UNITED STATES
NUCLEAR REGULATORY COMMISSION
REGION III
789 ROOSEVELT ROAD
GLEN ELLYN, ILLINOIS 60137

KERR-MCGEE CHEMICAL CORPORATION, WEST CHICAGO, ILLINOIS
LICENSE NO. STA-583 (DOCKET NO. 40-2061)
REQUEST FOR RADIATION SURVEYS OF BUILDINGS NO. 11, 12,
20 AND 21 AT KERR-MCGEE THORIUM FACILITY
(AITS NO. HO1317F3)

KERR-MCGEE CHEMICAL CORPORATION, WEST CHICAGO, ILLINOIS
LICENSE NO. STA-583 (DOCKET NO. 40-2061)
REQUEST FOR RADIATION SURVEYS OF BUILDINGS NO. 11, 12, 20
AND 21 AT KERR-MCGEE THORIUM FACILITY

FIGURE 1

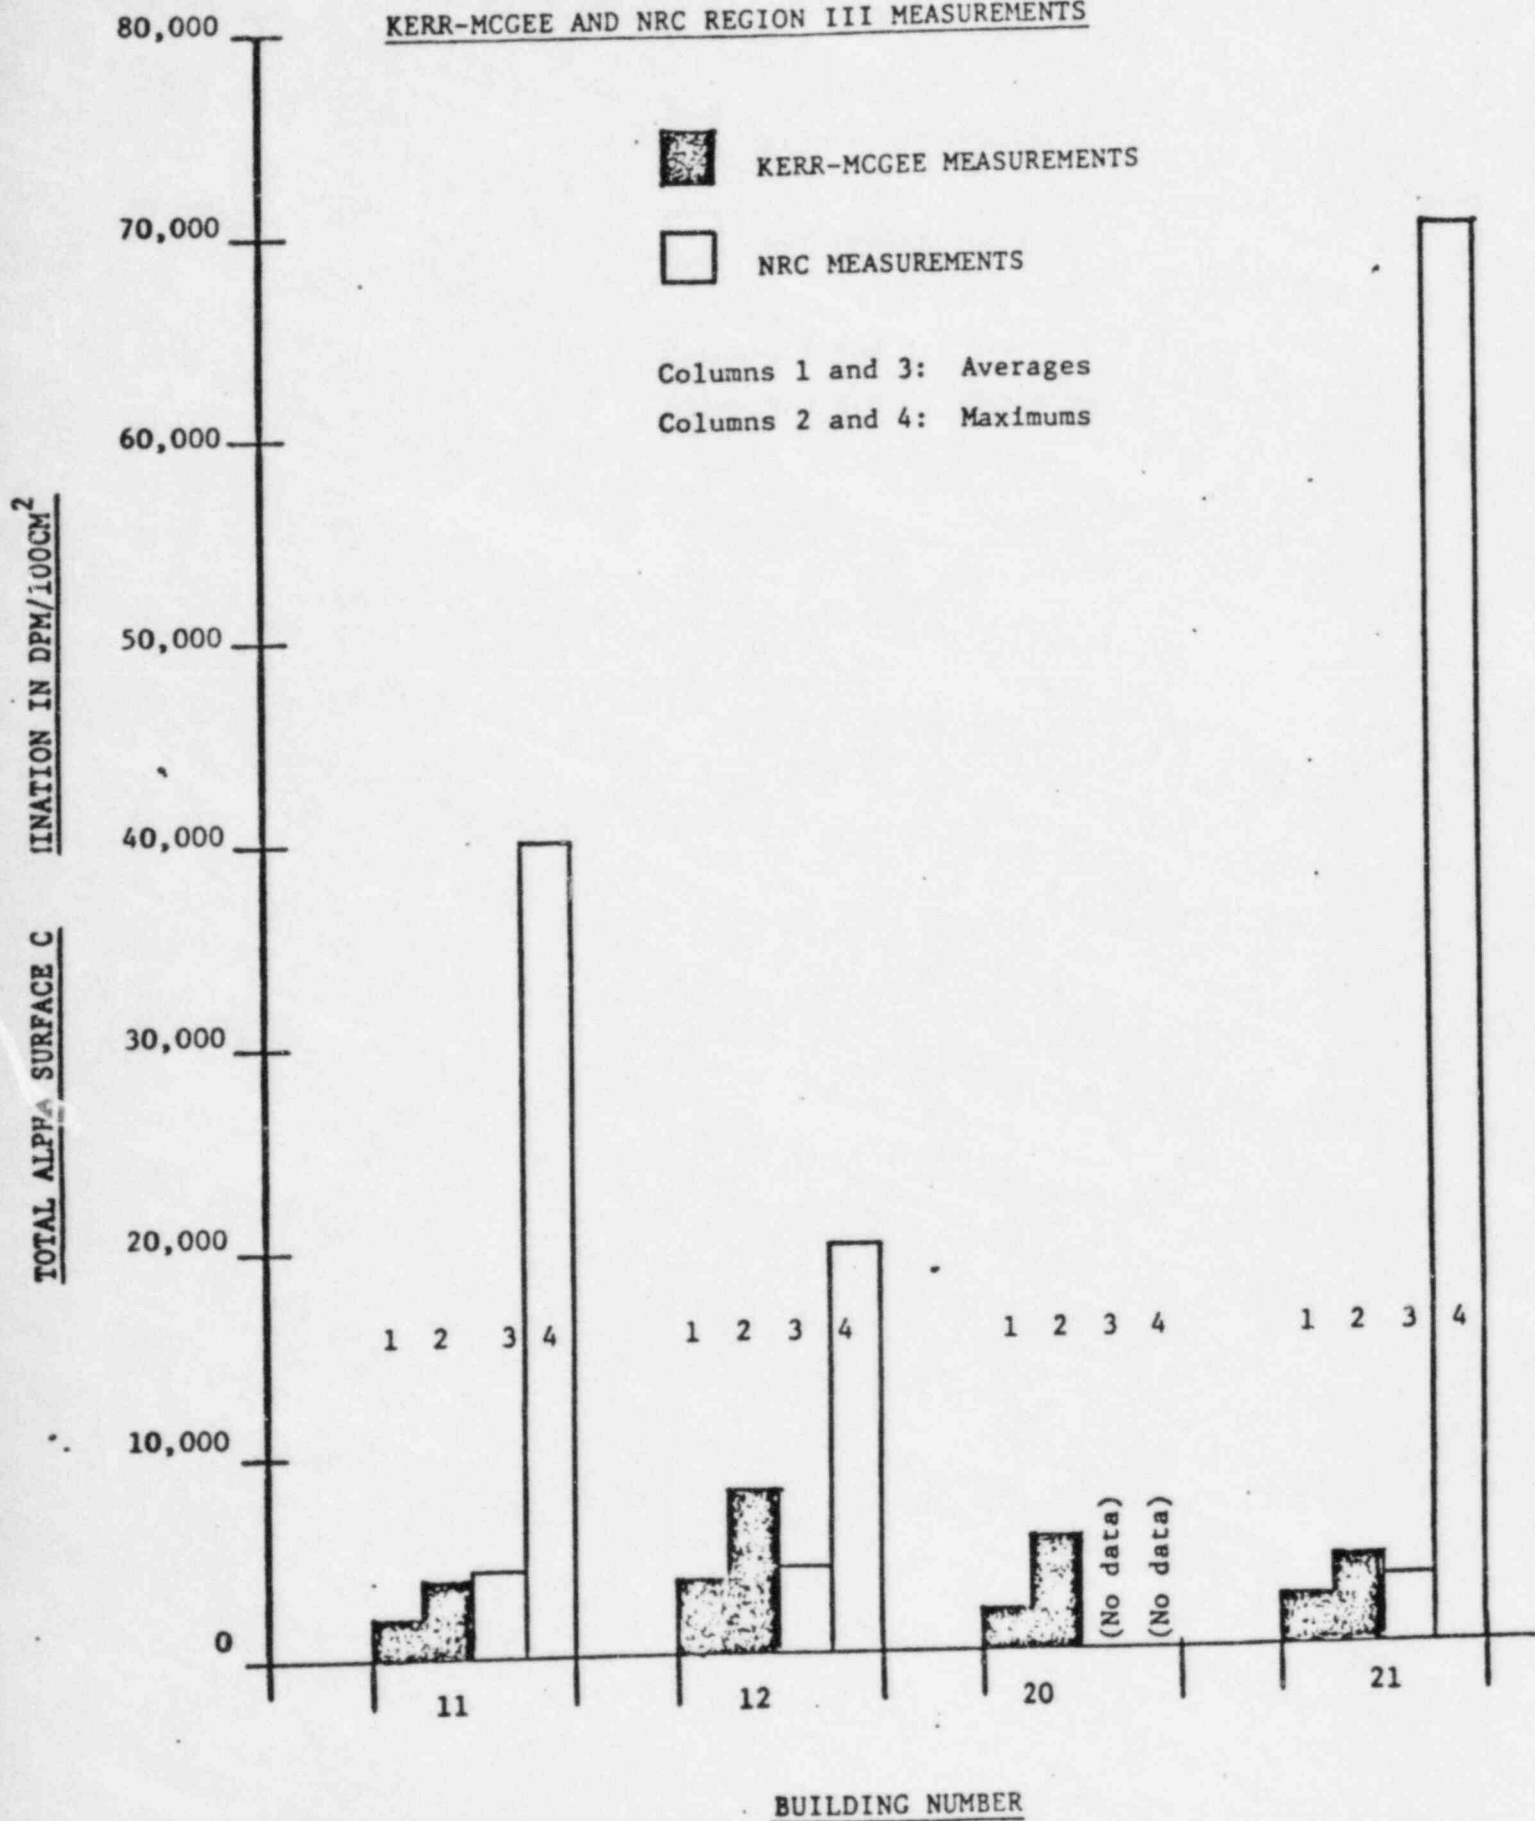
By comparison to data presented in Table I, the "Preliminary Survey" performed by Kerr-McGee personnel in the West Chicago facility is presented in Table II. The total alpha surface contamination data is graphically compared in Figure 1.

Based upon the total and removable surface contamination levels of radioactivity as determined by Region III personnel and presented in Table I of this report, Region III personnel concluded by comparison to standard guideline levels (Table III) that the four buildings (Nos. 11, 12, 20 and 21) located at the Kerr-McGee Chemical Corporation Thorium Facility in West Chicago, Illinois should not be released for unrestricted use and further, that partial release of the plant facilities not be permitted until all decontamination to acceptable levels is accomplished and verified.
